AWC Number of Water Body: 244-10-10050-2089-3015
(if known)

Name of Water Body: *Tim Mid Creek
(if known)

Nomination # : 25-008

- UPDATE/ADJUST hydrography of existing AWC Stream #244-10-10050-2089-3015.
- EXTEND existing AWC Stream #244-10-10050-2089-3015 with COHO salmon REARING.
- ADD local name "Tim Mid Creek" to existing AWC Stream #244-10-10050-2089-3015.

Map # 3

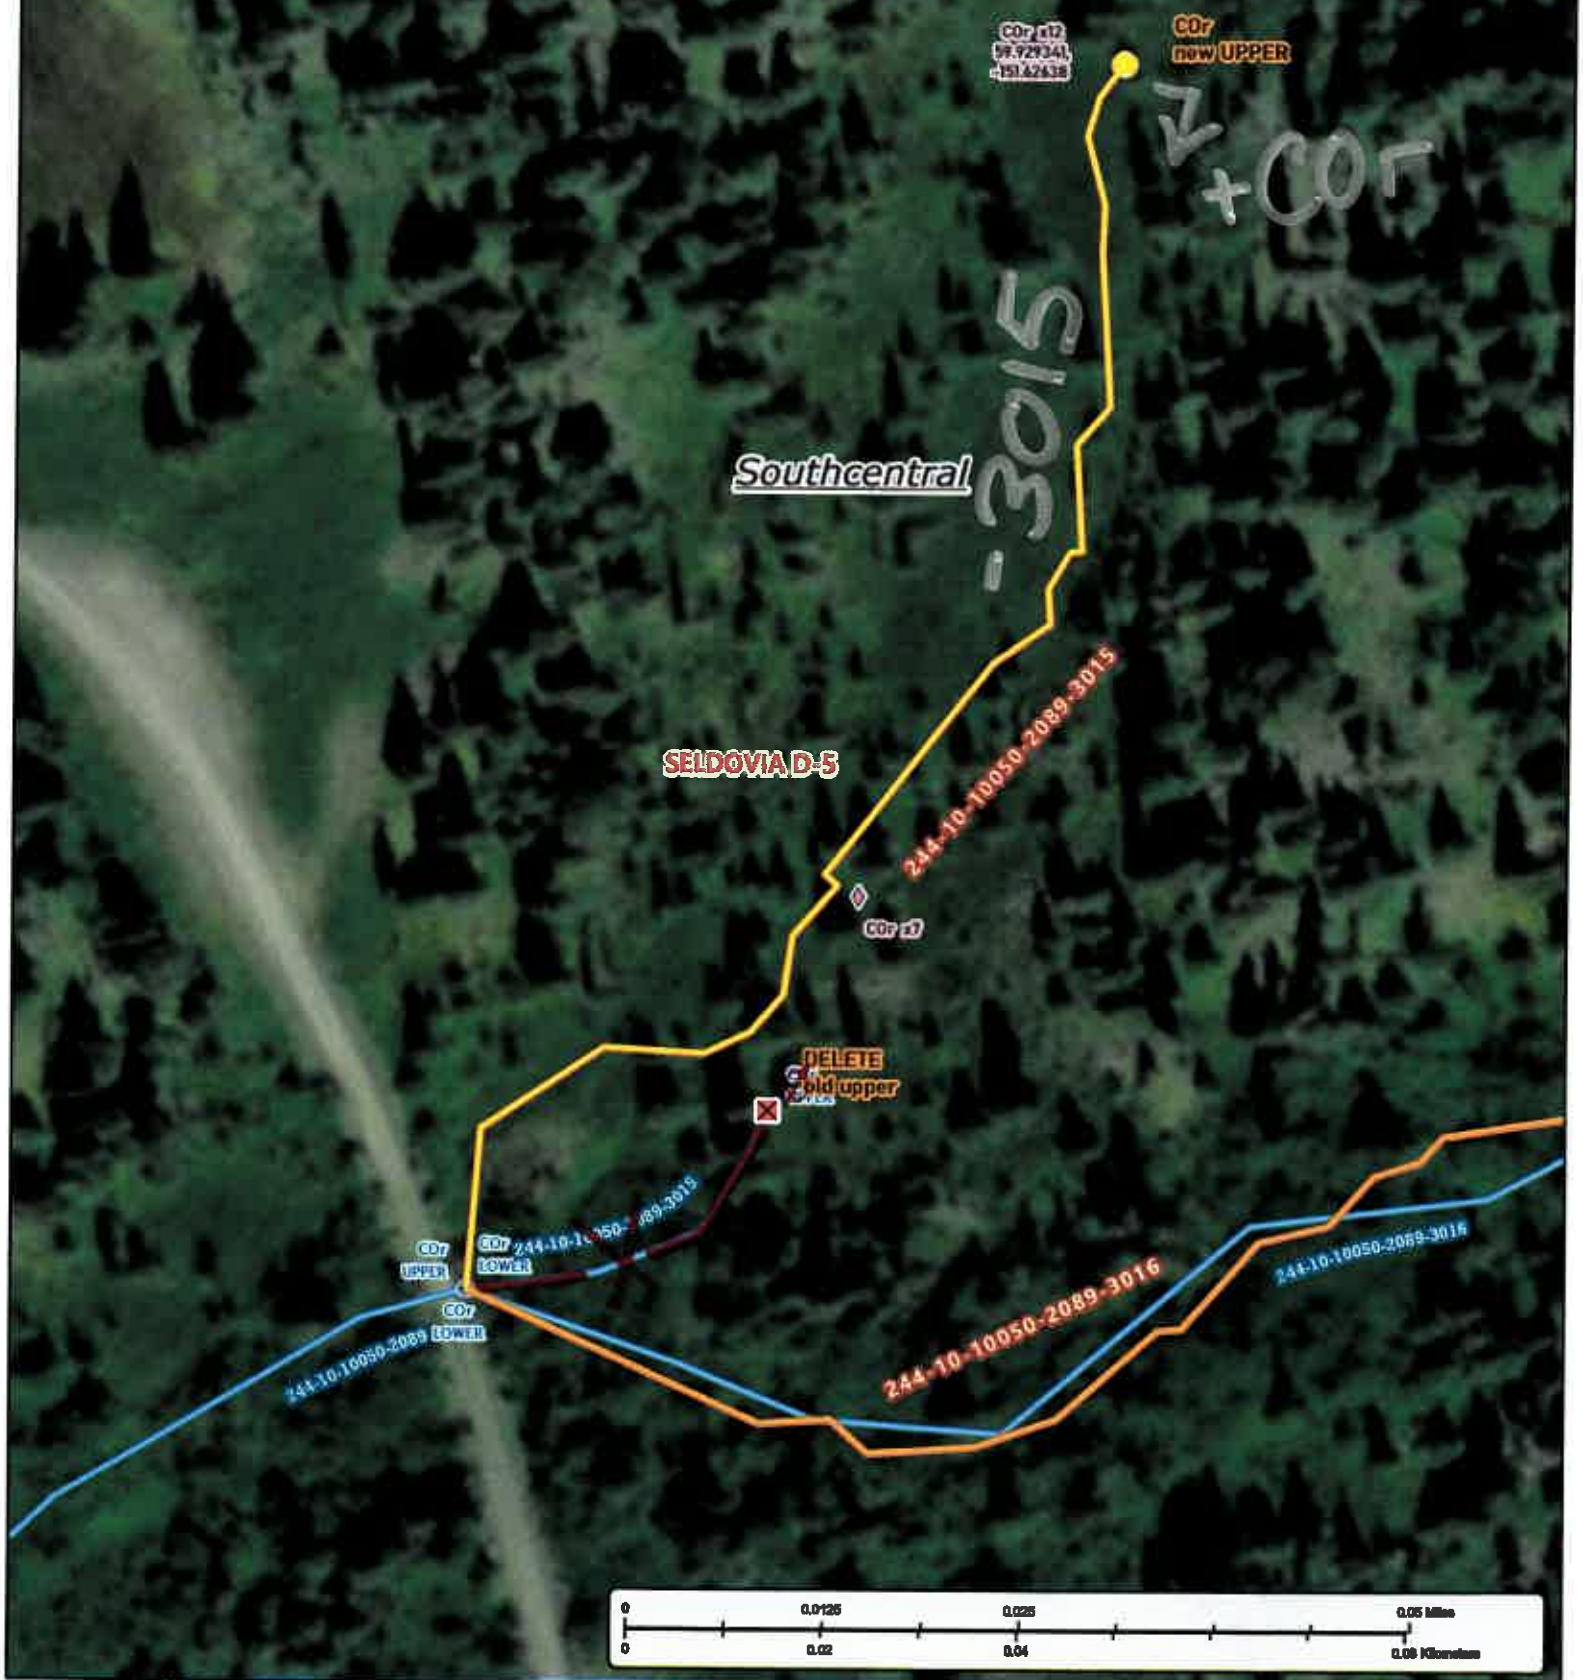
-UPDATE/ADJUST hydrography of existing AWC Stream #244-10-10050-2089-3015.
 -EXTEND existing AWC Stream #244-10-10050-2089-3015 with COMO aslmon REARING.
 -ADD local name "Tim Mld Creek" to existing AWC Stream #244-10-10050-2089-3015.
 + Please update using most recent .GDB with line, point, lake, polygon and barrier features located in C:\D6FR\AWC\Draw\2022\GIS\1Data\AWC2022_Writing\1_7Apr2022.gdb
